# Work Order ID 84921

Item Name: Skidtube RH

# **DART SERVICE INSTRUCTION**

**TO AMEND INSTALLATION INSTRUCTIONS IIN-D209-669 REV. B**

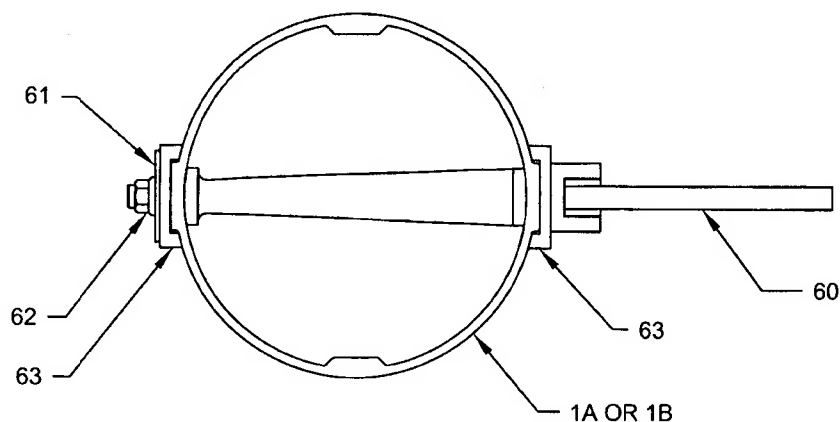
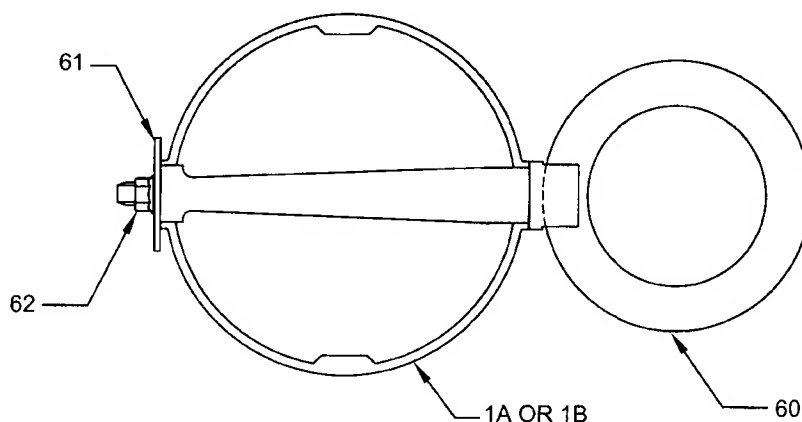
INSTALL TOW RING ASSEMBLY AS SHOWN BELOW (REFER TO SECTION F-F OF IIN-D209-669 REV. B.

**IS:**

**WAS:**

- a) REPLACE THE D2968-041 TOW RING WITH THE D3407-041 TOW RING ASSEMBLY.
- b) REPLACE THE D2736-1 AND D2736-3 GHW LUGS WITH THE D3405-041 AND D3405-043 LUG ASSEMBLIES.
- c) AMEND THE PARTS LIST IN SECTION 5.0 OF INSTALLATION INSTRUCTIONS IIN-D209-669 REV. B AS SHOWN ON PAGE 2 OF THIS DSI.
